**Flood Control Project Maintenance
Levee Inspections**
LMA District Cover Sheet
Spring 2017 Levee Inspection Results

Brannan Andrus Levee Maintenance District

Waterway			Bank	Unit Miles
Unit No. 01 Georgiana Slough			Right	6.01
	Spring (March - May)	Summer (June - August)	(September - November) Fall	Winter (December - February)
Unit Maintenance Rating (Fall Only)				
Date of Inspection	3/21/2017 - 3/21/2017			
DWR Inspector	Richard Willoughby			
Accompanied By	Gilbert Labrie DCC Engineering Co, Inc

Levee Inspection Report By Mile - Spring 2017

Photo 1 of 1 : SP_2017_NA0002_62_17_20170314_00011.jpg

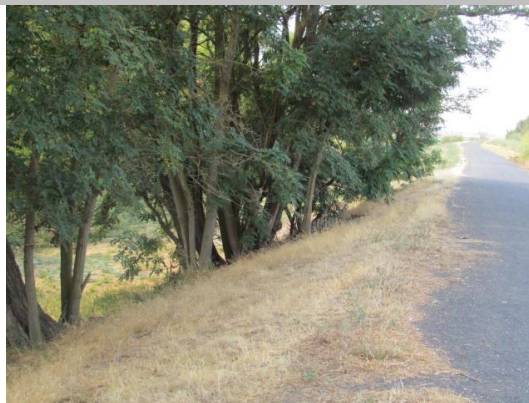
LM Start	5.78	Rating **	M	Issue No.	17
LM End	5.81	Issue Type +	Ma	Location *	LS
Category	Earthen Levee			GPS Latitude/Longitude	
				Start	End
Item	Trim / Thin Trees			38.129537 °	38.129599 °
				-121.582760 °	-121.582155 °
DWR ID	DWR_NA0002_01_s _ 2012_17				
Comment Code					
T1 : Trim trees to at least five feet above ground level.					
Inspector Comment					
Trim trees for visibility.

Looking at dense trees on landward slope and toe.

Photo 1 of 1 : SP_2017_NA0002_63_108_20170314_00075.jpg

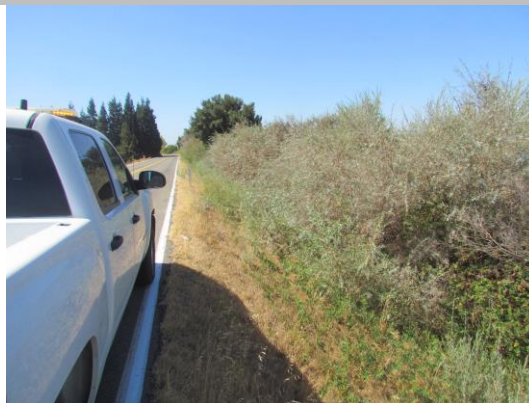
LM Start	0.73	Rating **	U	Issue No.	108
LM End	0.79	Issue Type +	Ma	Location *	WS
Category	Earthen Levee			GPS Latitude/Longitude	
				Start	End
Item	Vegetation			38.187031 °	38.186511 °
				-121.579588 °	-121.580470 °
DWR ID	DWR_NA0002_02_f_2016_108				
Comment Code					
V2 : Remove the wild growth other than native grasses from the levee slopes.					
Inspector Comment					
Dense willows on waterward slope.

Looking southwest at dense willow trees on waterward slope.

Photo 2 of 3 : SP_2017_NA0002_63_8_20170314_00008.jpg

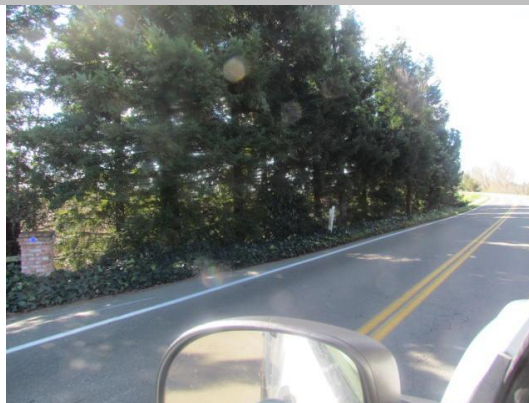
LM Start	0.80	Rating **	U	Issue No.	8 (cont)	
LM End	0.83	Issue Type +	En	Location *	LS	
Category	Earthen Levee			GPS Latitude/Longitude		
				Start		End
Item	Vegetation			38.186455 °		38.186215 °
				-121.580712 °		-121.581060 °
DWR ID	DWR_NA0002_02_s_2012_8					
Comment Code						
V6 : Landscaping						
Inspector Comment

Looking southwest at dense landscaping on landside slope.

Photo 2 of 2 : SP_2017_NA0002_63_37_20170314_00041.jpg

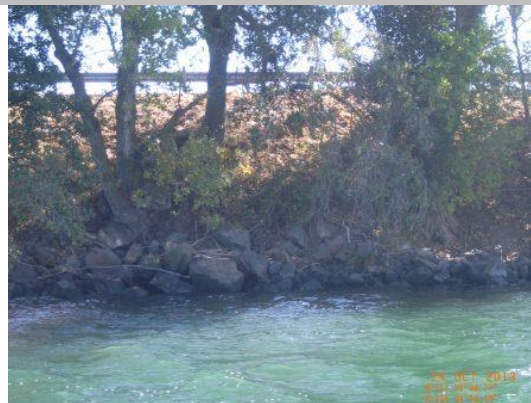
LM Start	2.66	Rating **	M	Issue No.	37 (cont)
LM End	2.74	Issue Type +	Ma	Location *	WS

Photo 1 of 2 : SP_2017_NA0002_63_34_20170314_00038.jpg

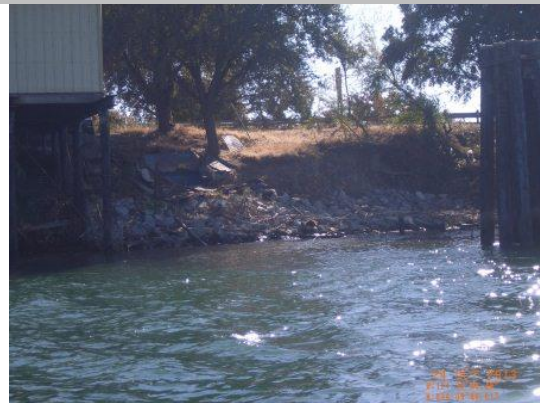
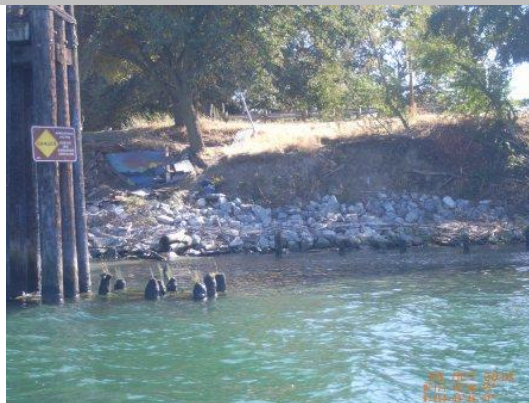
Comment Code					
Inspector Comment					
2009 - Fluvial erosion, into the levee slope, close to vertical bank with roadway on top. Pilings that were once at the bankline are now 30 ft out. 2010 - Very steep slope with slumps and overturned trees. 2011 - Upgraded to CRITICAL. Sections of vertical slope with highway on top. Heavy vegetation in front of most of the erosion pockets. Structures built into the levee on the upstream end. 2012 - Site continues to worsen. 2013 - Some rock added on the upstream end, but site remains critical. 2015: More rock has been placed in spots along the toe, but it is still insufficient. [2015 Site ID: SAC_17-2_L]

Comment Code					
Inspector Comment					
2009 - Fluvial erosion, into the levee slope, close to vertical bank with roadway on top. Pilings that were once at the bankline are now 30 ft out. 2010 - Very steep slope with slumps and overturned trees. 2011 - Upgraded to CRITICAL. Sections of vertical slope with highway on top. Heavy vegetation in front of most of the erosion pockets. Structures built into the levee on the upstream end. 2012 - Site continues to worsen. 2013 - Some rock added on the upstream end, but site remains critical. 2015: More rock has been placed in spots along the toe, but it is still insufficient. [2015 Site ID: SAC_17-2_L]

Photo 1 of 1 : SP_2017_NA0002_63_20_20170314_00023.jpg

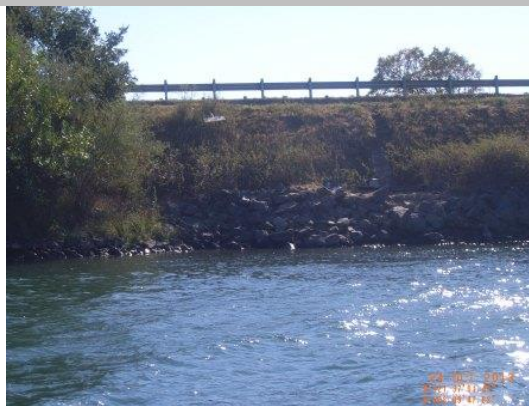
LM Start	3.62	Rating **	U	Issue No.	20
LM End	3.73	Issue Type +	Ma	Location *	WS
Category	Supplemental			GPS Latitude/Longitude	
				Start	End
Item	2015 USACE Erosion Survey, DRAFT			38.162959 °	38.163334 °
				-121.617323 °	-121.619312 °
DWR ID	DWR_NA0002_02_s _ 2016_20				
Comment Code					
Inspector Comment					
2008 - Overstepped levee section with pocket erosion. Plans for repair currently in the design phase. 2010 - Very steep slope with slumps, longitudinal cracking, and overturned trees. 2011 - Upgraded to CRITICAL. Sections of vertical slope with highway on top. Heavy vegetation in front of most of the erosion pockets. 2015: New rock placed on the levee slope for most of the downstream end, but bad spots still remain. [2015 Site ID: SAC_16-8_L]

Photo 1 of 3 : UCIP_SP_2017_12768_20731.jpg

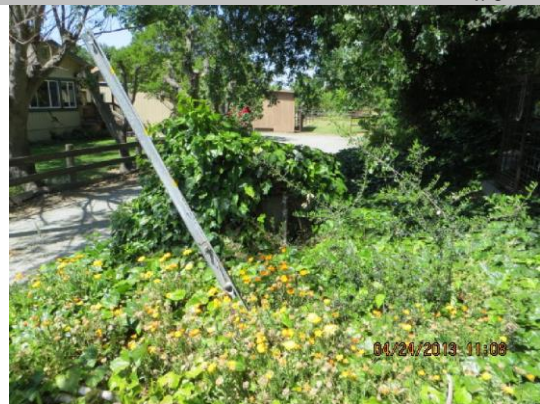
LM Start	4.11	Rating **	M	Issue No.	144
LM End	4.11	Issue Type +	En	Location *	LS
Category	Supplemental			GPS Latitude/Longitude	
				Start	End
Item	DWR UCIP Field Study			38.165016 °	38.165016 °
				-121.625834 °	-121.625834 °
DWR ID					
Comment Code					
Inspector Comment					
FS_ID:12768 DS_ID:21904 EP_NO: 787 Repair Type: Non-Urgent Crossing Status: Found UCIP Comments: Pipe may be abandoned and should be done so properly if not being used. Good candidate for video inspection. FIELD_STRUCT_DESC: 2 of 2: 14-inch steel irrigation pipe through levee 4.2 feet below crown. Pump on pile structure in stream (Permit No. 787, 1939). Included in the 1959 O&M manual. FS Date: 4/24/2013

Concrete distribution box at LS toe.

Photo 2 of 3 : SP_2017_NA0002_63_9_20170314_00011.jpg

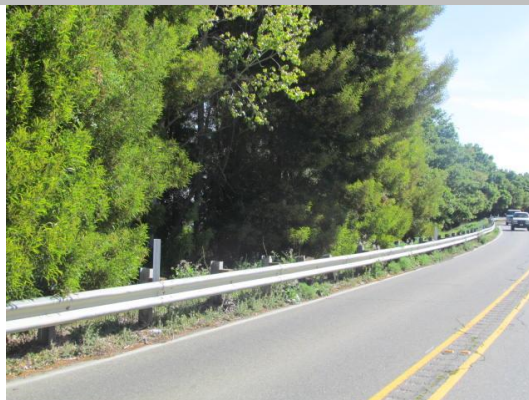
LM Start	5.23	Rating **	U	Issue No.	9 (cont)
LM End	5.42	Issue Type +	Ma	Location *	WS

Looking east at dense trees on waterward shoulder and slope.

Photo 1 of 2 : SP_2017_NA0002_63_14_20170314_00017.jpg

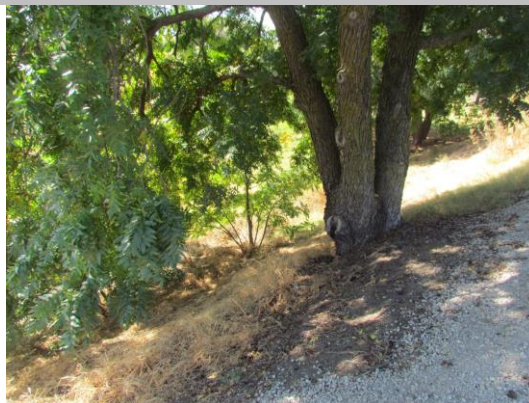
LM Start	6.36	Rating **	U	Issue No.	14
LM End	6.36	Issue Type +	Ma	Location *	LS
Category	Earthen Levee			GPS Latitude/Longitude	
				Start	End
Item	Trim / Thin Trees			38.173406°	38.173406°
				-121.663815°	-121.663815°
DWR ID	DWR_NA0002_02_s_2012_14				
Comment Code					
T1 : Trim trees to at least five feet above ground level.					
Inspector Comment
